4.1 Pre-App 1 (ref 2019/0151/PRE) Cont'd

4.2 Pre-App 2 (ref 2019/2724/PRE)

5.0 Proposal

First Floor Plan (as submitted on Jan.9th 2019 ref:2019/0151/PRE)

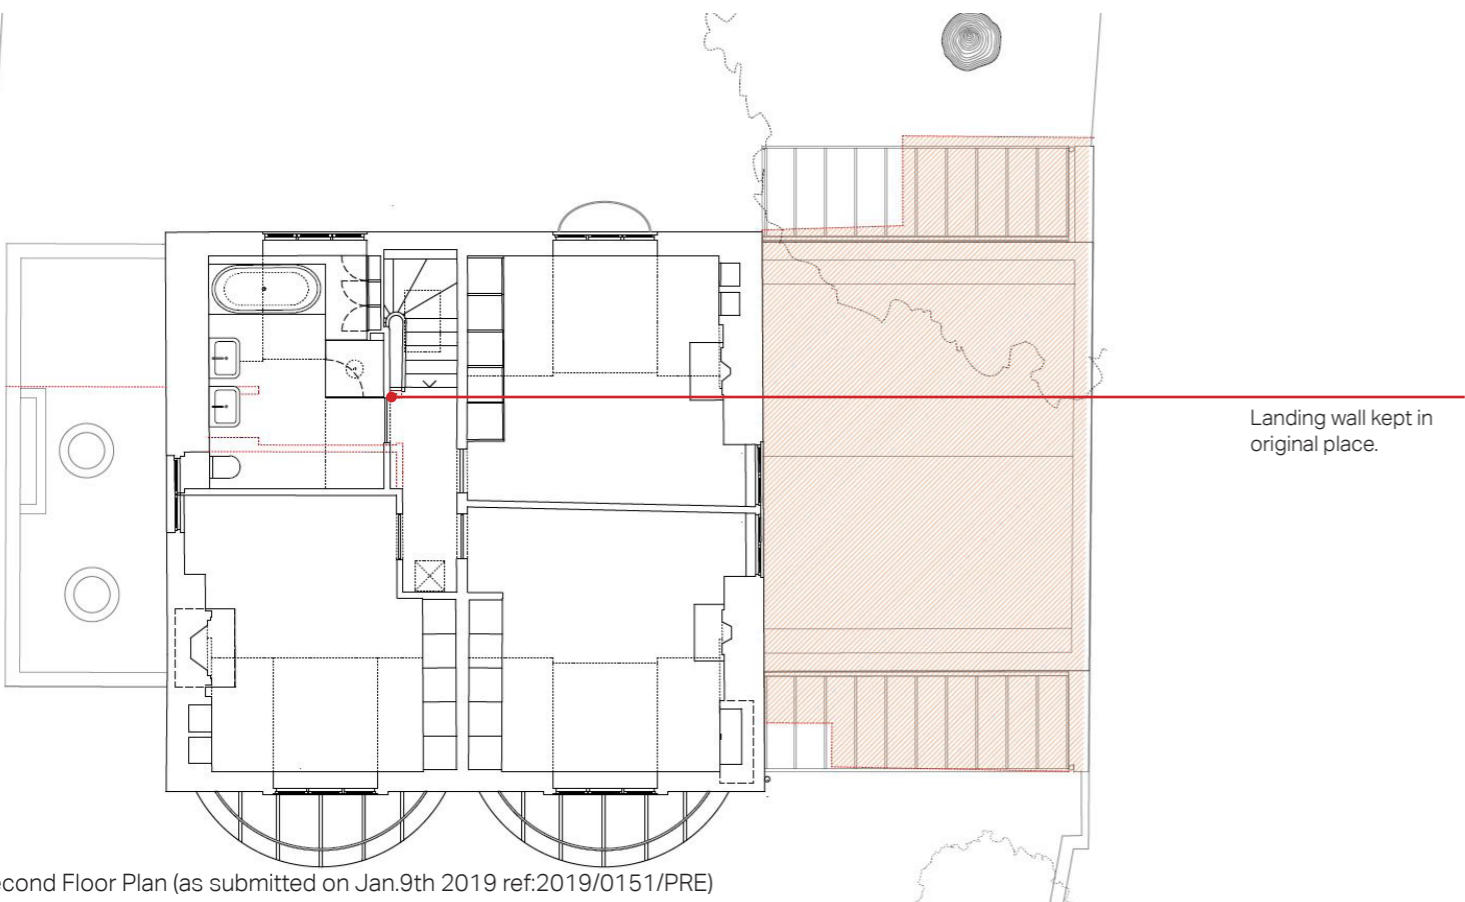
- The proposed door opening between the front two rooms was concealed with two flush jib doors on each face of the wall to maintain the form of the rooms.
- The original section of the nib partition in the rear WC, previously shown to be removed, was retained.

Line of proposed extension pushed back.

Proposed roof changed to hipped lead roof.

Existing wall partially retained

Jib door introduced to both sides

Front roof glazing reduced in area by 40%
